SUBDIVISION AUTHORITY MINUTES MEETING NO. 34

RE: Tentative plan of subdivision to create 44 row housing units, one (1) medium density residential lot, and one (1) Public Utility lot from the SW 25-52-26-4, located north of Whitemud Drive NW and east of 231 Street Street NW; **ROSENTHAL**

RE: Tentative plan of subdivision to create 113 single detached residential lots, 68 semi-detached residential lots and 25 row housing lots from Lot A, Plan 4270 NY, Lot A, Block 7, Plan 152 4703 and the W ½ of the NE 31-52-25-W4M, located south of Stony Plain Road NW and west of 199 Street NW; **STEWART GREENS**

RE: Tentative plan of subdivision to create 304 single detached residential lots, and one (1) Municipal Reserve lot, from Lot 1, Block C, Plan 082 0895, and the NE-31-51-23-W4M located south of 23 Avenue NW and west of 17 Street NW; **LAUREL**

SUBDIVISION CONDITIONS OF APPROVAL MAP

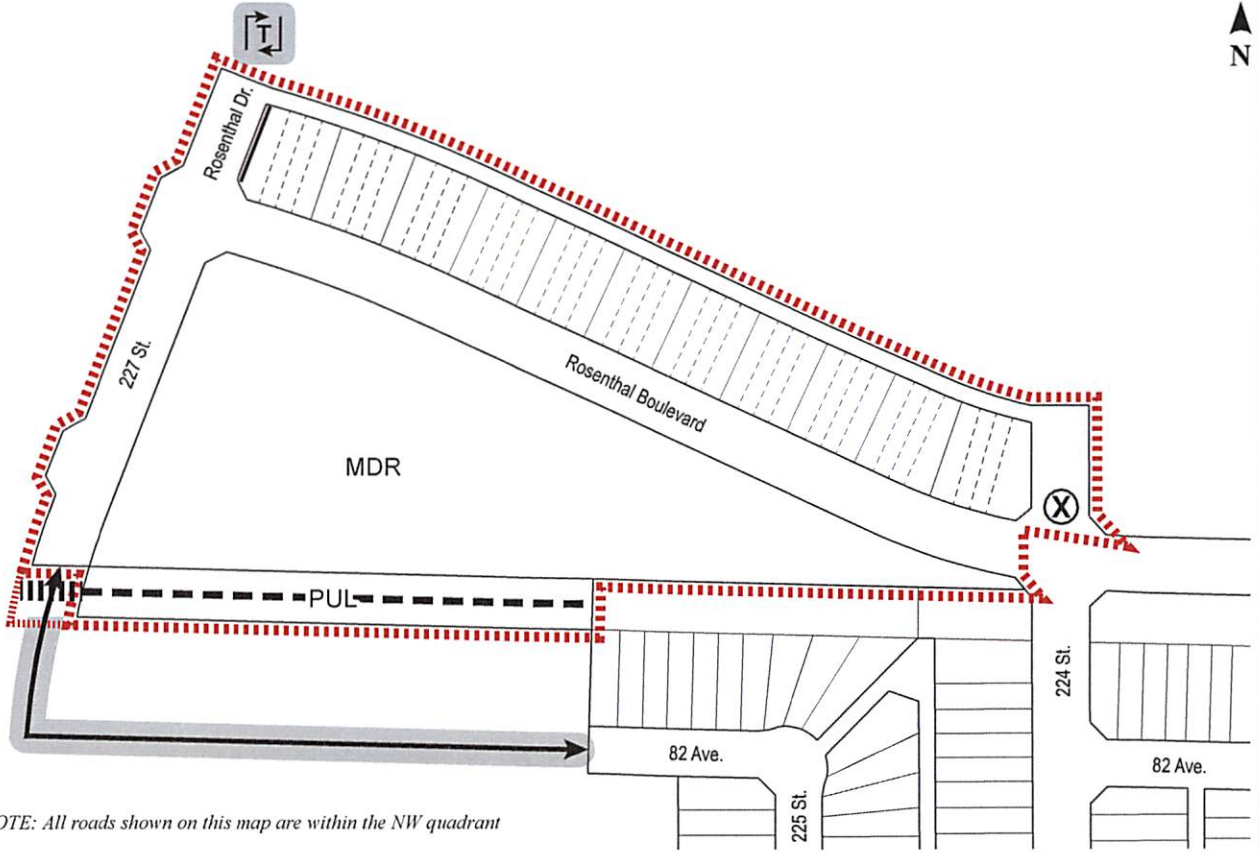
7. that the owner construct a 3 m hard-surface shared use path with "Shared Use" signage, and bollards, as shown on the "Conditions of Approval" map, Enclosure I;

8. that the engineering drawings include a temporary 4 m wide gravel emergency access with T-bollards, as shown on the "Conditions of Approval" map, Enclosure I. The temporary emergency access will be required prior to CCC for roads (or at the discretion and direction of Transportation Planning and Engineering);

11. that the owner provide a zebra marked crosswalk with curb ramps and pedestrian signage to the satisfaction of Transportation Planning and Engineering, as shown on the "Conditions of Approval" map, Enclosure I;

12. that the engineering drawings include curb extensions at the shared use path to the satisfaction of Transportation Planning and Engineering;
13. that the engineering drawings include a temporary offset 17 m radius transit turnaround to the satisfaction of Transportation Planning and Engineering, as shown on the "Conditions of Approval" map, Enclosure I. This turnaround will require a gravel surface prior to CCC for roads, and a paved surface prior to FAC for roads (or when required by Transportation Planning and Engineering);

14. that the owner remove the existing transit turnaround to the satisfaction of Transportation Planning and Engineering, as shown on the "Conditions of Approval" map, Enclosure I;

16. that the owner construct all fences wholly on privately owned lands to the satisfaction of Transportation Planning and Engineering and Parks and Biodiversity, as shown on the "Conditions of Approval" map, Enclosure I; and
17. that the owner is responsible for the design, landscaping and construction within the Public Utility lots to the satisfaction of Drainage Planning and Engineering and Transportation Planning and Engineering.

SUBDIVISION CONDITIONS OF APPROVAL MAP

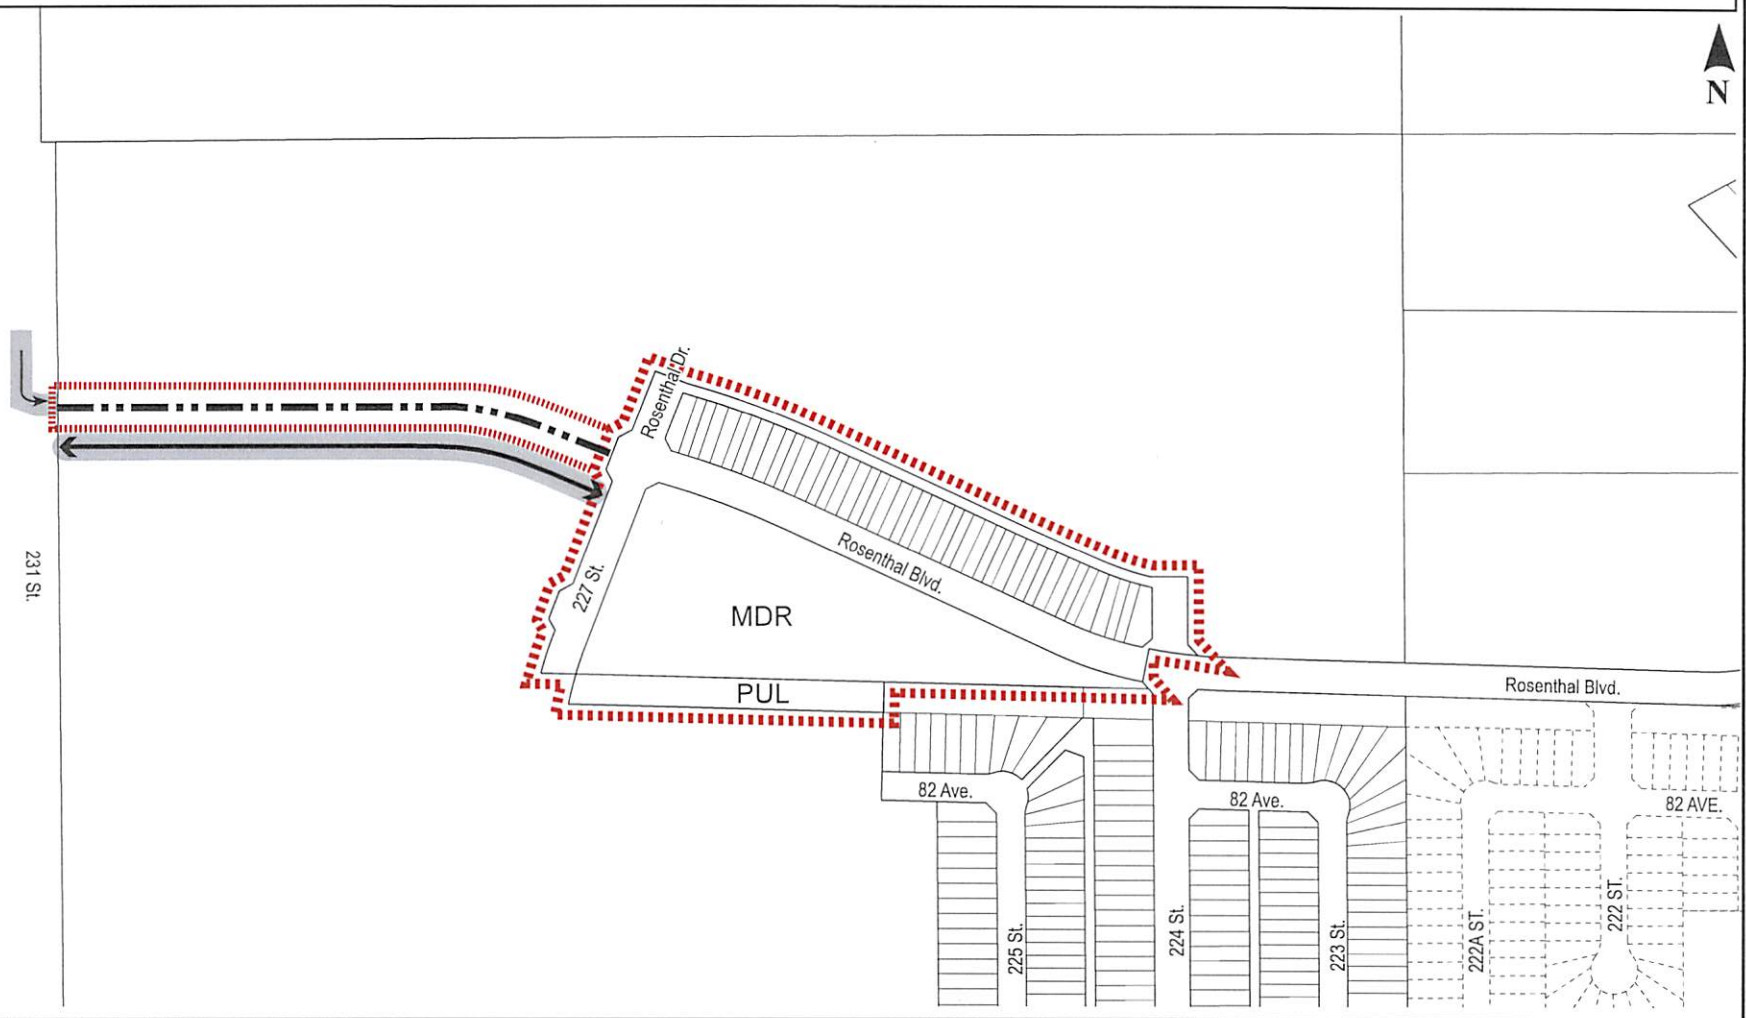
3. that the subdivision boundary be amended to include dedication of Rosenthal Boulevard to the satisfaction of Transportation Planning and Engineering, as shown on the "Conditions of Approval" map, Enclosure I and II;

9. that the engineering drawings include a temporary 9 m wide paved rural roadway with lighting, as shown on the "Conditions of Approval" map, Enclosure II. This roadway will be required prior to CCC (or when required by Transportation Planning and Engineering);

10. that the engineering drawings include a temporary south bound left turn bay to the satisfaction of Transportation Planning and Engineering, as shown on the "Conditions of Approval" map, Enclosure II;

15. that the owner construct Rosenthal Boulevard to the satisfaction of Transportation Planning and Engineering, as shown on the "Conditions of Approval" map, Enclosure II. This roadway will be required prior to CCC for roads (or when required by Transportation Planning and Engineering). The permanent collector roadway must be open and operational by November 30, 2019;

SUBDIVISION CONDITIONS OF APPROVAL MAP

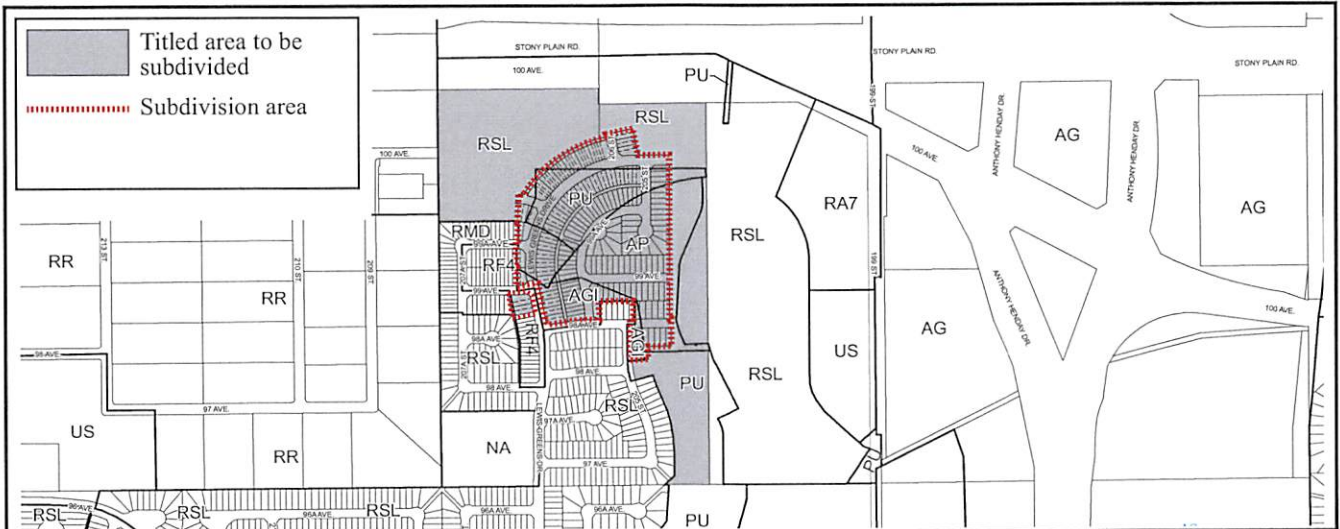
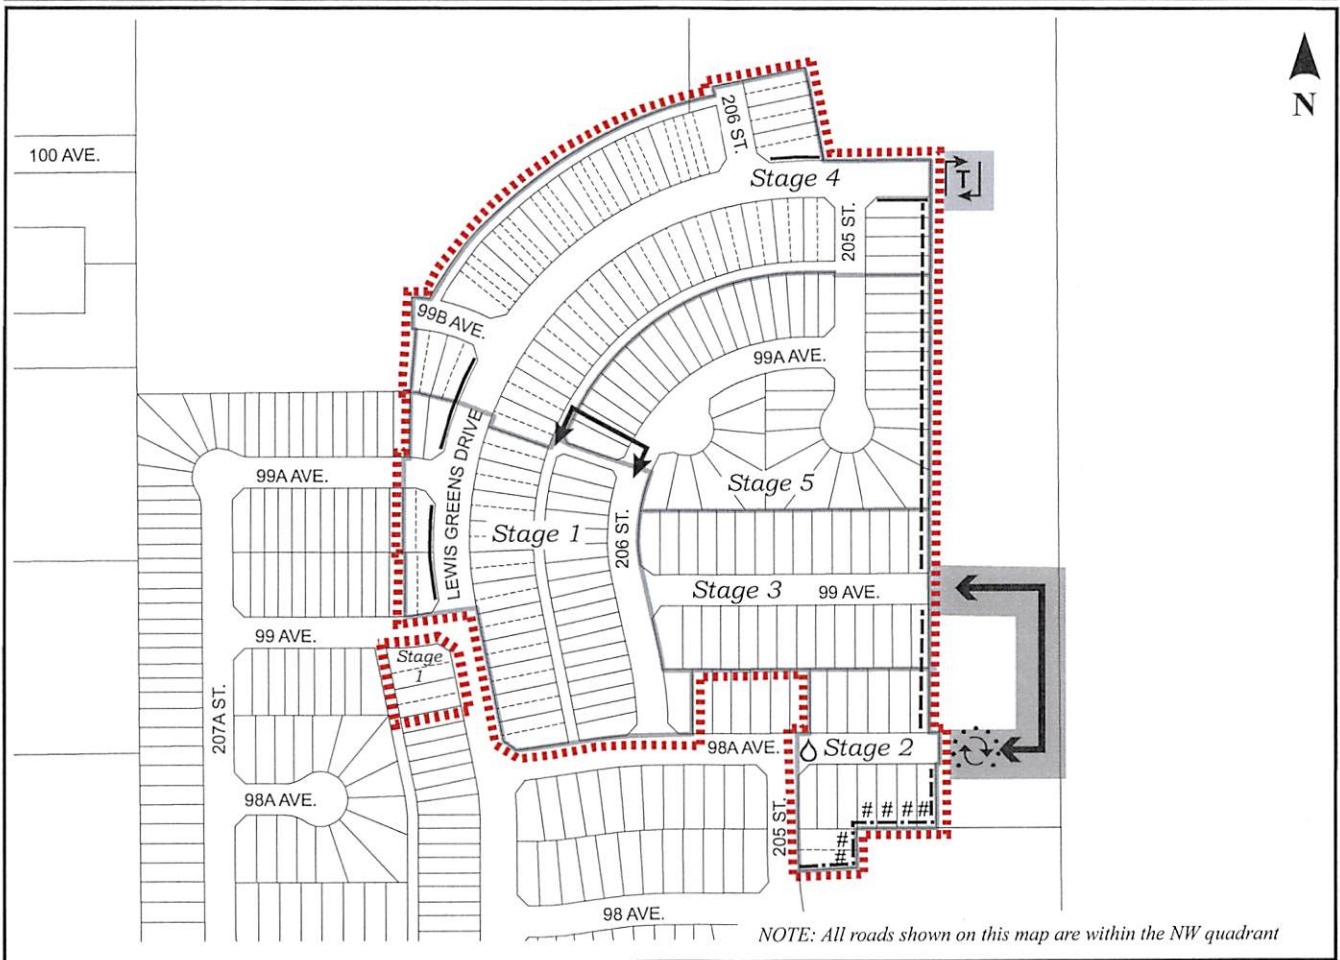
3. that Bylaw 17765 to amend the Edmonton Zoning Bylaw shall be approved prior to the endorsement of this subdivision;
4. that the owner register a freeboard restrictive covenant in favour of the City of Edmonton against the lots backing onto the SWMF, as shown on the "Conditions of Approval" map, Enclosure I;

5. that the owner be permitted to register this plan in stages, at the discretion of the Chief Subdivision Officer, having regard for the provision of roadways, Municipal Reserves (MR), and the logical extension of services, as shown on the "Conditions of Approval" map, Enclosure I; and

8. that the engineering drawings include a temporary 12 m radius gravel surface turnaround with bollards or mini-barriers, to the satisfaction of Transportation Planning and Engineering, as shown on the “Conditions of Approval” map, Enclosure I. This roadway will be required prior to CCC for roads (or when required by Transportation Planning and Engineering);

9. that the engineering drawings include an offset temporary 17 m radius gravel surface transit turnaround with bollards or mini-barriers, to the satisfaction of Transportation Planning and Engineering, as shown on the “Conditions of Approval” map, Enclosure I. This roadway will be required to be asphalt surface prior to FAC (or when required by Transportation Planning and Engineering);

10. that the engineering drawings include a temporary 6 m gravel surface roadway connection, to the satisfaction of Transportation Planning and Engineering, as shown on the “Conditions of Approval” map, Enclosure I. This roadway will be required prior to CCC for roads (or when required by Transportation Planning and Engineering);

11. that the owner upgrade the existing 150mm water main stub to a 200mm water main stub, to the satisfaction of EPCOR Water Services, as shown on the “Conditions of Approval” map, Enclosure I;

12. that the owner construct a temporary 6 m gravel surface emergency access with T-bollards, to the satisfaction of Transportation Planning and Engineering, as shown on the “Conditions of Approval” map, Enclosure I. This roadway will be required prior to CCC for roads (or when required by Transportation Planning and Engineering);

13. that the owner construct all fences wholly on privately-owned lands, to the satisfaction of Transportation Planning and Engineering and Parks and Biodiversity, as shown on the "Conditions of Approval" map, Enclosure I; and
14. that the owner is responsible for the landscape design and construction within road rights of way to the satisfaction of City Departments and affected utility agencies.

SUBDIVISION CONDITIONS OF APPROVAL MAP

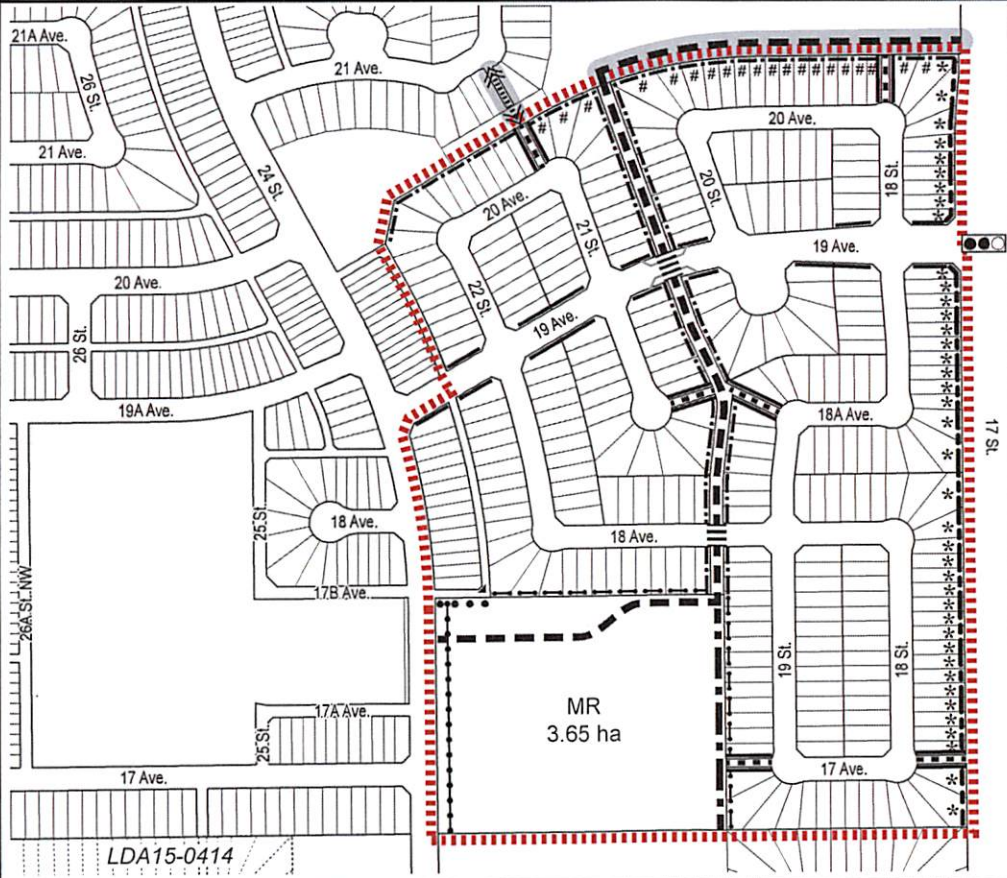
1. that the owner dedicate Municipal Reserve (MR) as a 3.65 ha lot pursuant to Section 666 of the Municipal Government Act as shown on the "Conditions of Approval" map, Enclosure I;

5. that Bylaw 17743 to amend the Edmonton Zoning Bylaw shall be approved prior to the endorsement of this subdivision;
6. that the owner dedicate walkways and greenways as road rights of way as shown on the "Conditions of Approval" map, Enclosure I;

7. that the owner dedicate a 3.5m x 3.5m corner cut to the satisfaction of Transportation Development Engineering as shown on the "Conditions of Approval" map, Enclosure I;

8. that the owner register a freeboard restrictive covenant in favour of the City of Edmonton against the lots backing onto the Storm Water Management Facility (SWMF) as shown on the "Conditions of Approval" map, Enclosure I;

9. that the owner register a noise attenuation berm restrictive covenant in favour of the City of Edmonton against the lots backing onto or flanking 17 Street NW, to protect the integrity of the berm, as shown on the "Conditions of Approval" map, Enclosure I; and
10. that the owner pay all outstanding property taxes prior to the endorsement of the plan of survey.

7. that the engineering drawings include a 200 mm offsite water main extension, to the satisfaction of EPCOR Water Services Inc., as shown on the "Conditions of Approval" map, Enclosure I;

8. that the engineering drawings include a 3 m hard surface shared use path with lighting, within the Storm Water Management Facility (SWMF), as per City of Edmonton Design and Construction Standards, to the satisfaction of Sustainable Development, as shown on the "Conditions of Approval" map, Enclosure I;

12. that the the owner construct a 1.5 m concrete sidewalk with lighting, and bollards, within the walkways, to the satisfaction of Transportation Planning and Engineering, as shown on the “Conditions of Approval” map, Enclosure I;

13. that the owner construct a 3 m hard surface shared use path, lighting and bollards, to the satisfaction of Transportation Planning and Engineering, as shown on the “Conditions of Approval” map, Enclosure I;

14. that the owner construct a 3 m hard surface shared use path, and bollards, to the satisfaction of Transportation Planning and Engineering, as shown on the “Conditions of Approval” map, Enclosure I;

15. that the owner provide a zebra marked crosswalk with curb ramps and pedestrian signage to the satisfaction of Transportation Planning and Engineering, as shown on the “Conditions of Approval” map, Enclosure I;

16. that the owner provide curb extensions at the shared use path crossing on the collector roadway to the satisfaction of Transportation Planning and Engineering, as shown on the “Conditions of Approval” map, Enclosure I;

17. that the owner install bollards to the satisfaction of Sustainable Development, as shown on the "Conditions of Approval" map, Enclosure I;
18. that the owner pay for the installation of traffic signals, as shown on the “Conditions of Approval” map, Enclosure I. The City of Edmonton shall complete the signal design, and the City’s Electrical Services Contractor must install the signals as per the agreement between the City of Edmonton and the Electrical Services Contractor. The timing of the traffic signals installation will be at the direction of Transportation Operations. If traffic signals are not deemed warranted by Transportation Operations within 5 years of signing the Servicing Agreement, the owner will be required to provide payment to the City of Edmonton for the installation of traffic signals at that time to fulfill this obligation;

19. that the owner construct a 1 m berm centered on property line and 1.8 m noise attenuation fence contained wholly within private property, as per the City of Edmonton Roadway Design Standards Drawing #5205 and in conformance with the accepted noise study, for all lots backing onto or flanking 17 Street NW, to the satisfaction of Transportation Planning and Engineering, as shown on the "Conditions of Approval" map, Enclosure I;

20. that the owner construct all fences wholly on privately-owned lands and/or Municipal Reserve lots, to the satisfaction of Transportation Development Engineering and Parks Planning, as shown on the “Conditions of Approval” map, Enclosure I; and
